WATTS BAR NUCLEAR PLANT (WBN) - UNITS 1 AND 2 - RESPONSE TO REQUEST FOR  
ADDITIONAL INFORMATION (RAI) - OUTSTANDING ISSUE 20(a) - FEEDWATER CHECK  
VALVE SLAM - TAC M79718 AND M80345

REFERENCE: NRC letter to TVA, November 20, 1992, Request for Additional  
Information on Outstanding Issue 20(a)

RESPONSE TO REQUEST FOR ADDITIONAL INFORMATION (RAI)  
OUTSTANDING ISSUE (20a)  
FEEDWATER CHECK VALVE SLAM (TAC M79718 AND M80345)

**FIGURE 1: ASME Lower Bound True Stress-Strain Curve**  
SA-333 Grade 6 Material

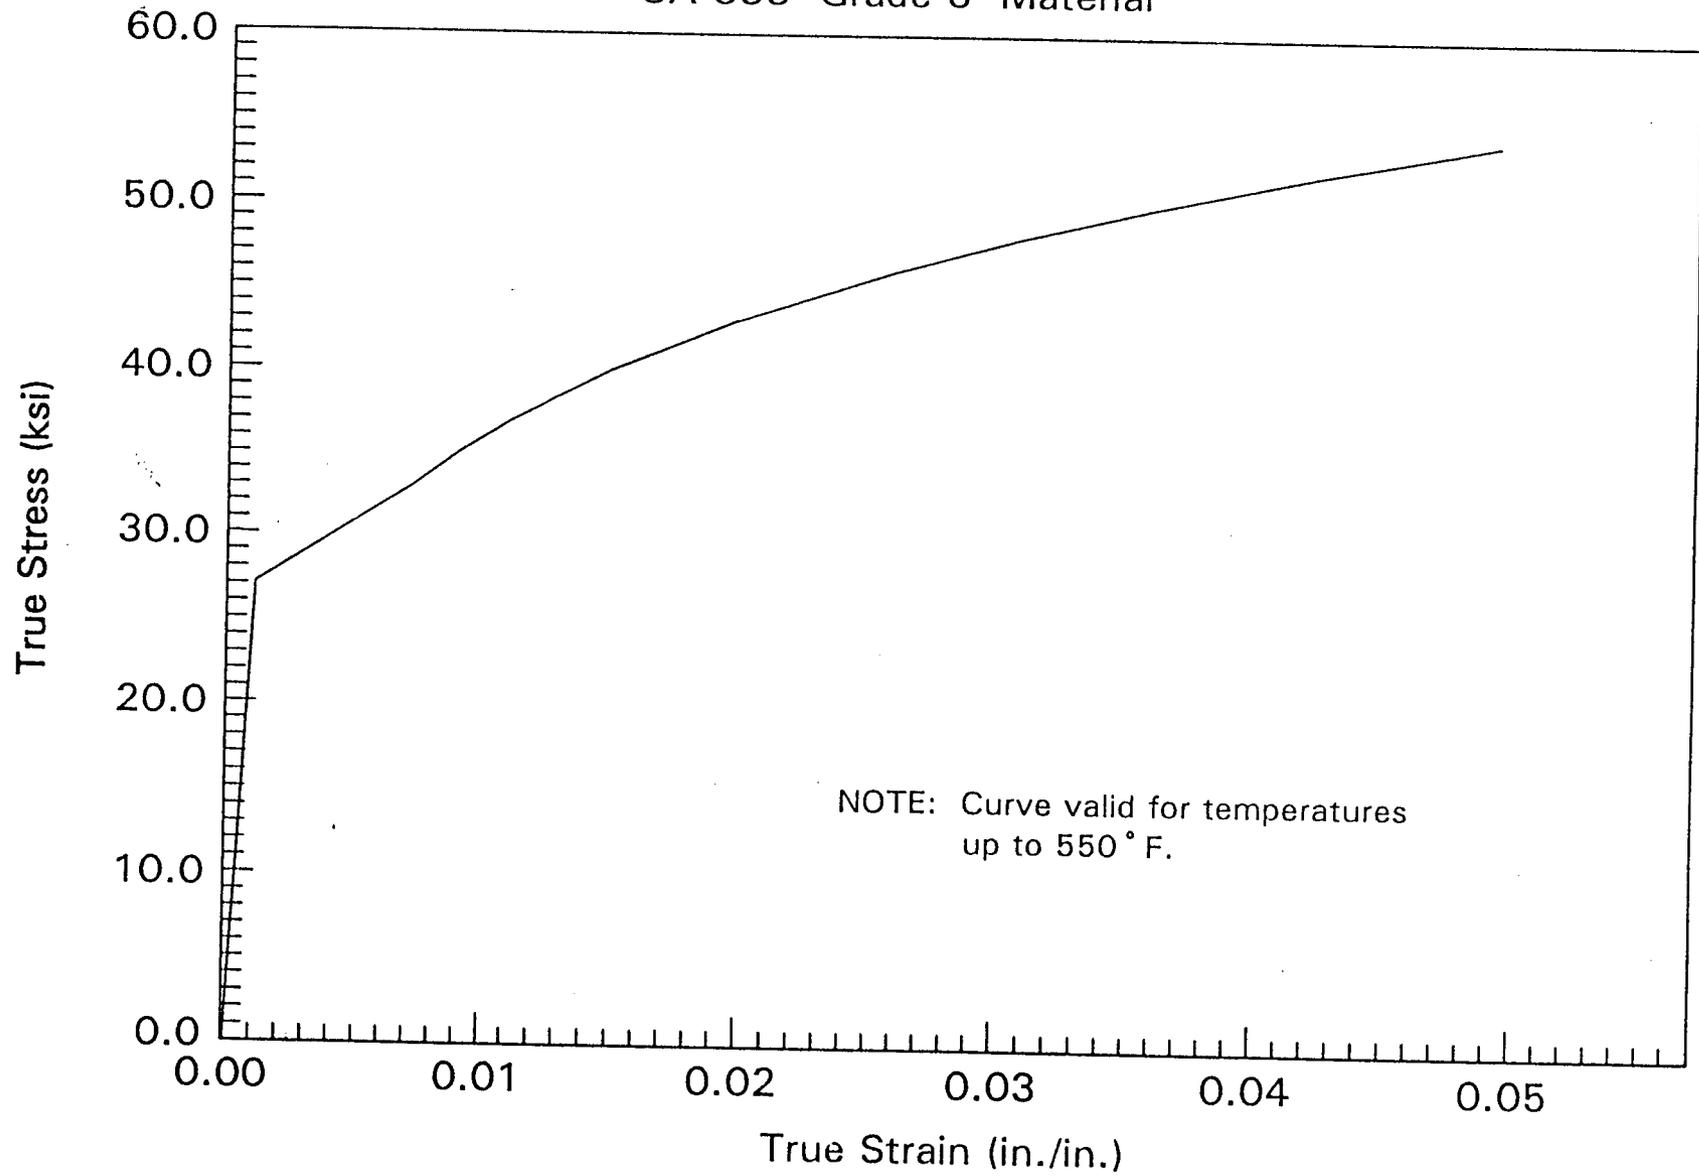
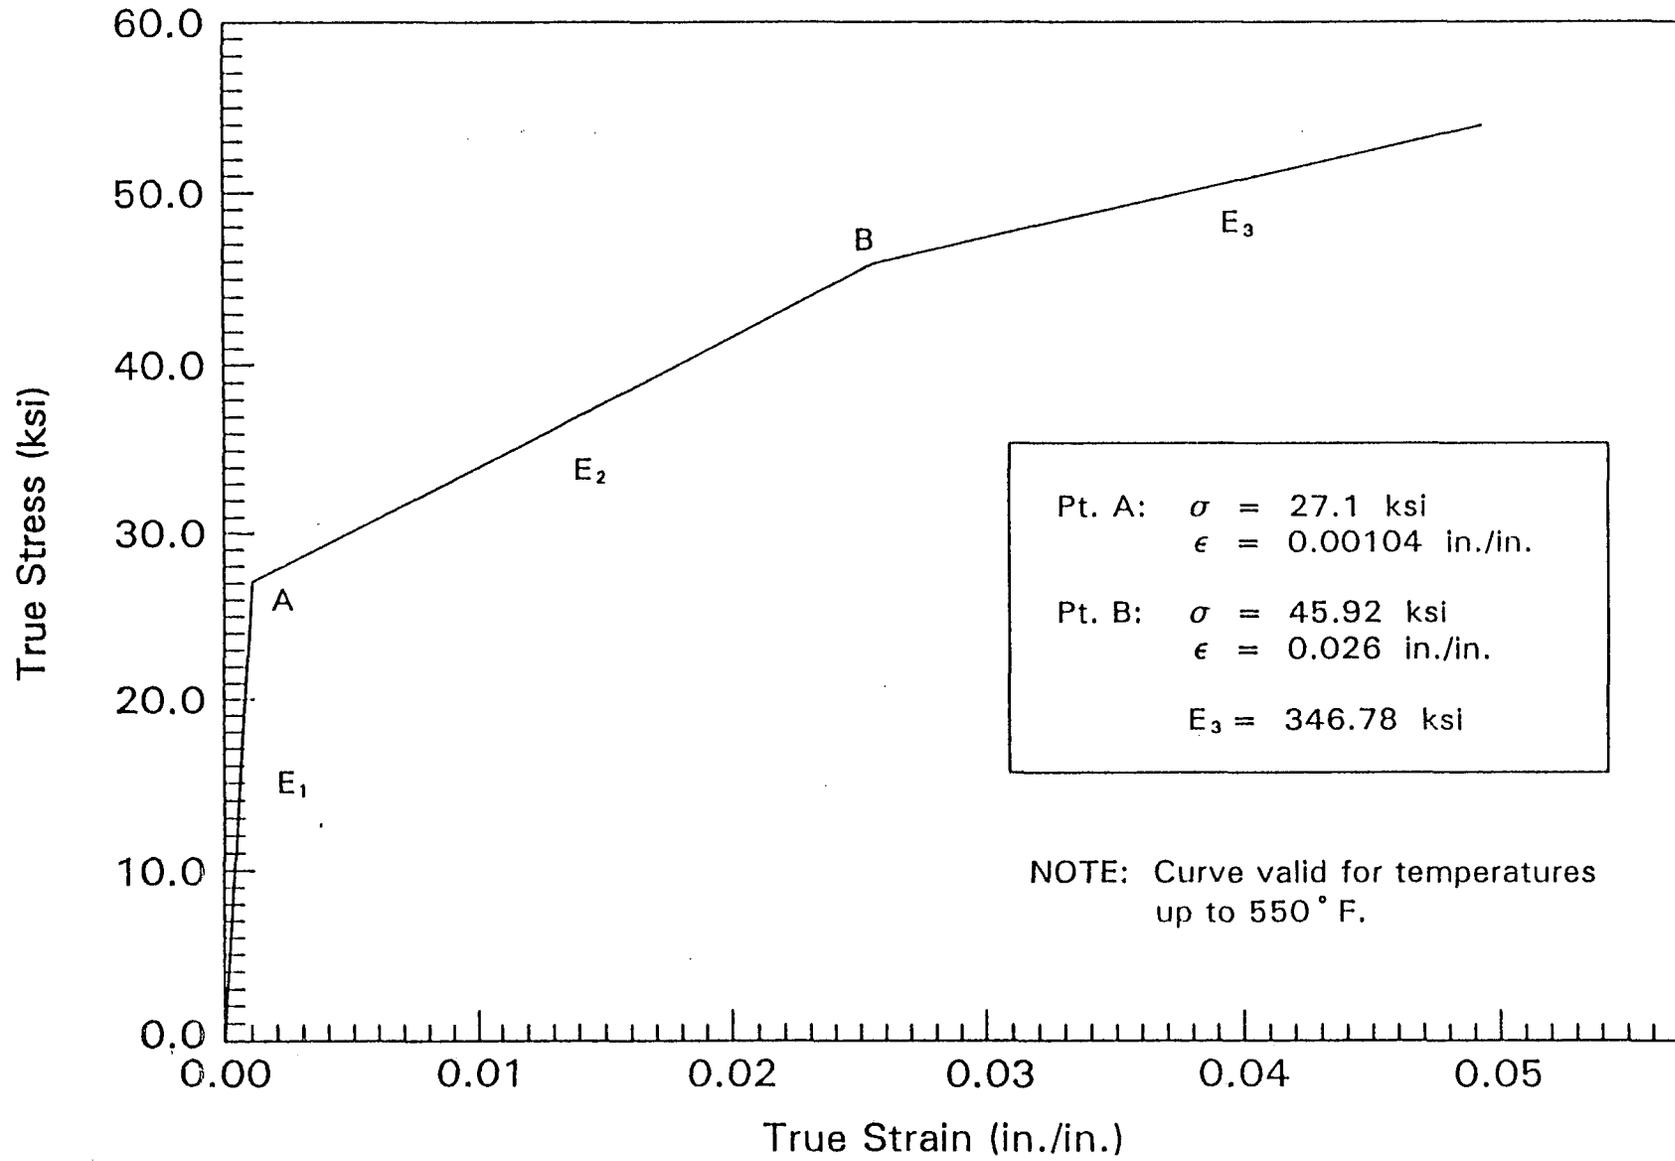
Question 1 - The response states that "Material properties used in the nonlinear analysis have been revised to be consistent with the results of ASME Code-sponsored tests." In order for the staff to evaluate the adequacy of the properties used in the nonlinear analysis, please identify the ASME Code-sponsored tests and describe which material properties were revised to be consistent with the test results.

Response - The "ASME Code-Sponsored tests" referred to are key materials development testing of SA-333, Grade 6 ferritic steel that was performed to support Section XI of the Code. The information obtained from the tests are the properties needed to characterize the stress-strain relationship for the piping material (SA-333, Grade 6).

The source data used to define the stress-strain data used in the evaluation of the WBN Feedwater line were taken from References 1.1 and 1.2.

These two sources provide data for ten stress-strain curves of SA-333, Grade 6 material that formed the bases for a lower bound curve that was used to construct the tri-linear representation used for the WBN Feedwater analysis (See Attachment 1). As shown in the attachment, key numerical values from the analysis curve are:

$$\begin{aligned}S_y &= 27.1 \text{ ksi} \\S_u &= 65.6 \text{ ksi} \\E &= 26.0 \times 10^6 \text{ psi}\end{aligned}$$

The lower bound curve was compared to CMTR data for the WBN feedwater lines to ensure that the lower bound material curve is representative of the installed material. CMTR data was not used as input to the analyses.

Response - An excerpt from Drawing 48W1707-19, showing PD 07-20 from Loop 1, is shown below along with a sketch showing node and element numbers used in the model.

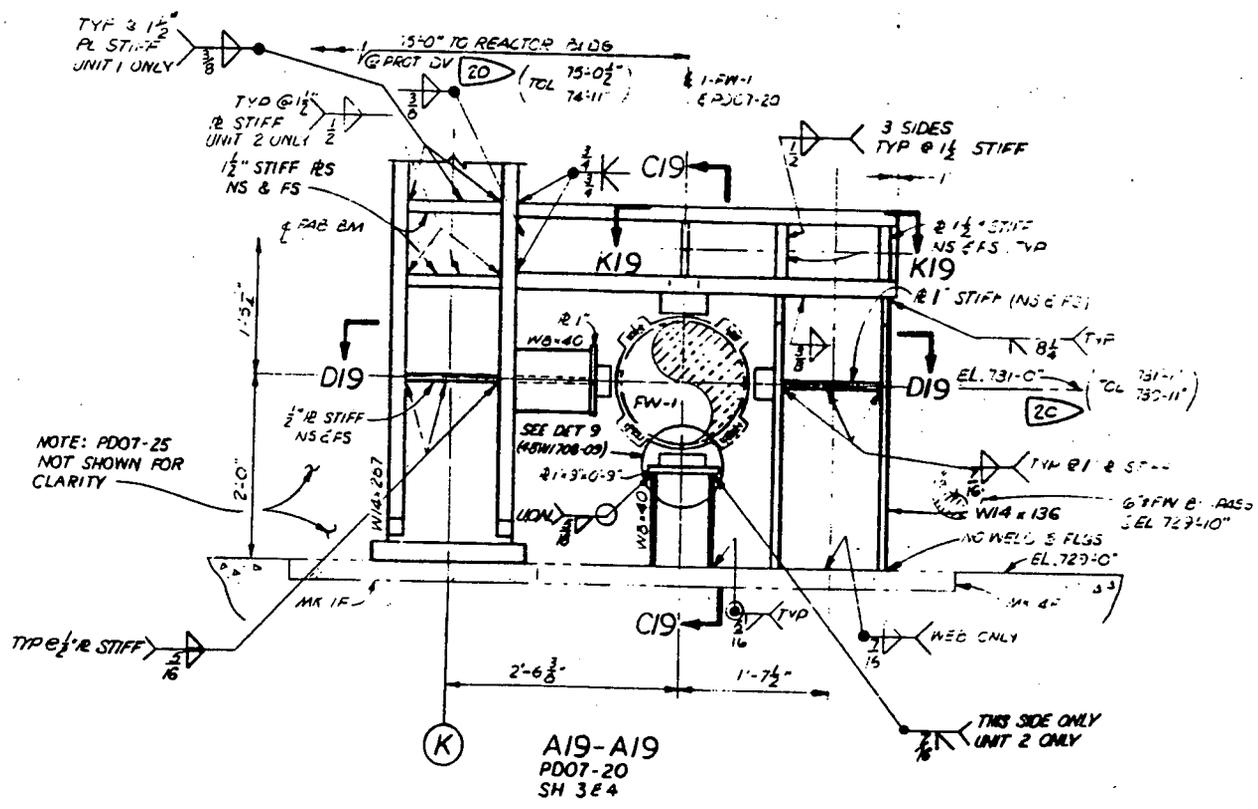
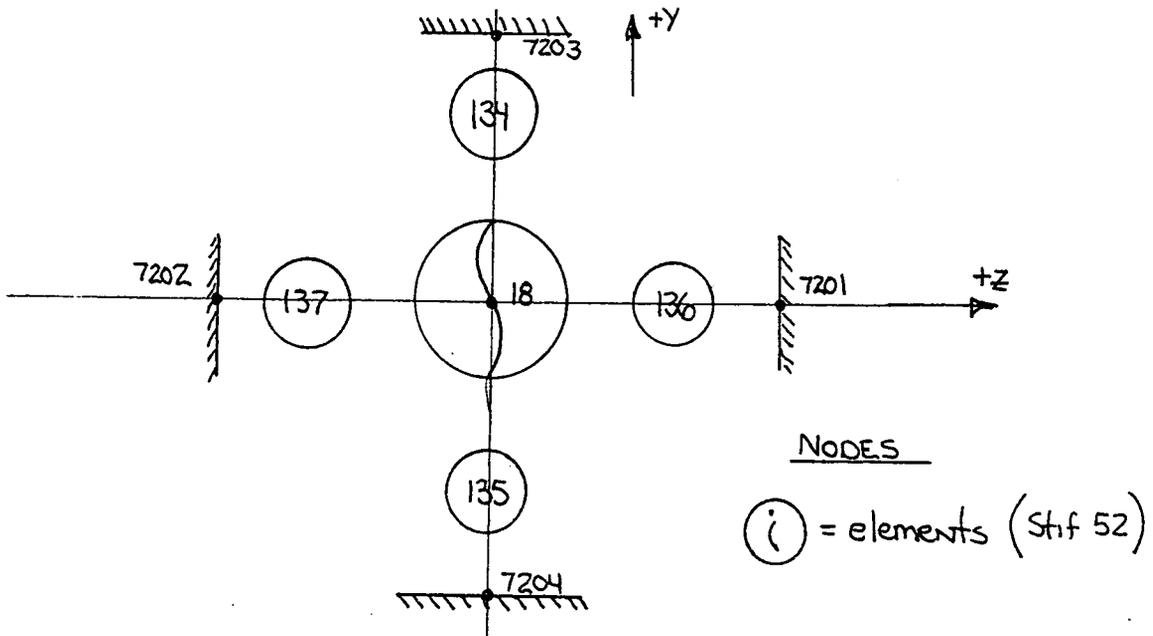
Item c - A sketch of a typical whip restraint showing the number and location of the gap elements; include node and element numbers.
